SUBJECT: TECHNICAL REVIEW OF "TANK 16H SPECIAL ANALYSIS FOR THE  
PERFORMANCE ASSESSMENT FOR THE H-TANK FARM AT THE  
SAVANNAH RIVER SITE", SRR-CWDA-2014-00106, REV. 1,  
FEBRUARY 2015 (DOCKET NO. PROJ0734)

## Technical Review of Special Analysis for Tank 16H

SRR-CWDA-2014-00106, Revision 1, "Tank 16 Special Analysis for the Performance Assessment for the H-Tank Farm at the Savannah River Site", Savannah River Remediation, LLC, Closure and Waste Disposal authority, Aiken, South Carolina, February 2015.

Figure 3. Water movement through grouted tank system under constant and fluctuating water table scenarios (adapted from SRR-CWDA-2014-00106)

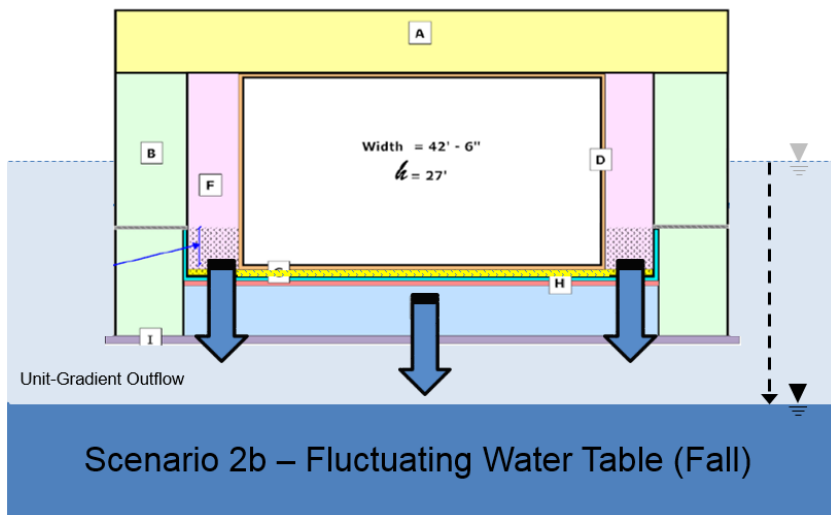
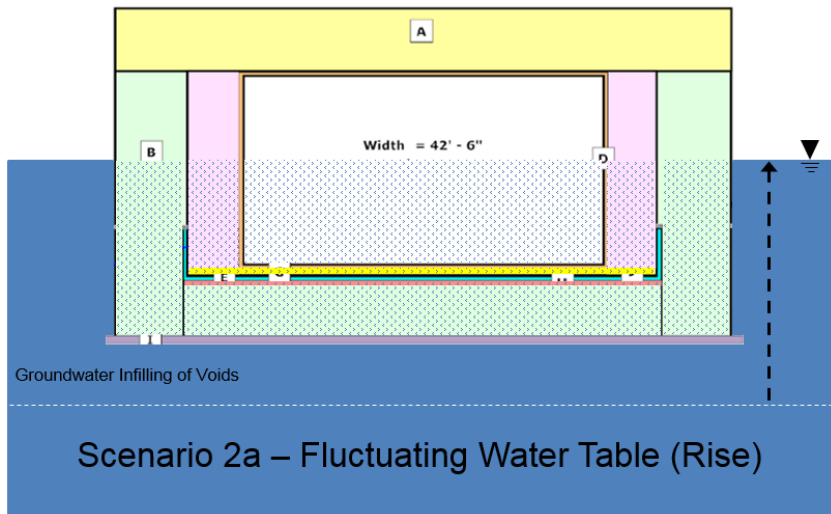
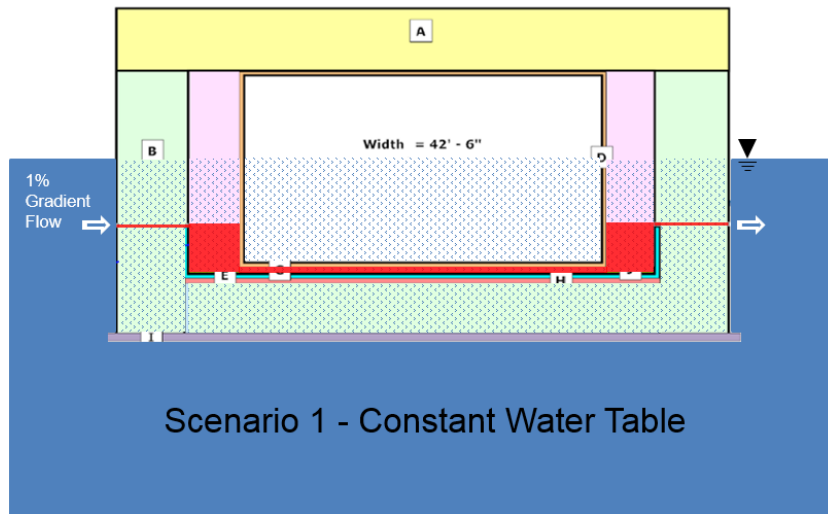
The assumption that the annulus grout is a significant flow barrier is problematic in this sensitivity case. NRC staff intended for DOE to run a case with a preferential pathway through the entire tank system, and not simulate a low conductivity grout that restricts flow in the preferential pathway through the annulus. Unless it can be demonstrated that shrinkage or cracking will not occur in the grout annulus, NRC staff continues to recommend that DOE evaluate radionuclide release from the annulus and sand pads with a continuous preferential pathway. Secondly, DOE assumes that the fast pathway is saturated with a 1% hydraulic gradient between the most upgradient and downgradient portions of the tank system (see Figure 3, Scenario 1). In the July 28-29, 2015, Onsite Observation Visit (ML15239A628), NRC staff reiterated their concern of the risk associated with the potential rise and fall of the water table. NRC staff thinks that the rise and fall of the water table is likely to be more risk significant for radionuclide release from the annulus than under a saturated flow condition. A rise and fall of the water table could be simulated with a unit hydraulic gradient (versus 0.01) and likely corresponds to a greater volume of water contacting the residual waste in the annulus (see

Figure 3, Scenarios 2a and 2b). If the possibility of this scenario cannot be excluded, it should be evaluated by DOE. In addition, the basis for the 1% hydraulic gradient to represent the potential across the resistive engineered barrier is not clear. If DOE relies on the AFZ analysis with the 1% hydraulic gradient, additional information should be provided to support this value. Lastly, the inventories of long-lived radionuclides (e.g., Pu-239, Np-237) are potentially risk significant and should be included in the AFZ analysis. Based on these limitations of the AFZ analysis, NRC staff concludes that DOE's Tank 16H Special Analysis does not adequately evaluate the potential risk associated with the Tank 16H annulus and sand pads. To address this technical issue, DOE could run additional simulations that consider the essential elements listed in the bullets above (e.g., consideration of shrinkage gaps, rise and fall of the water table, and long-lived radionuclides).
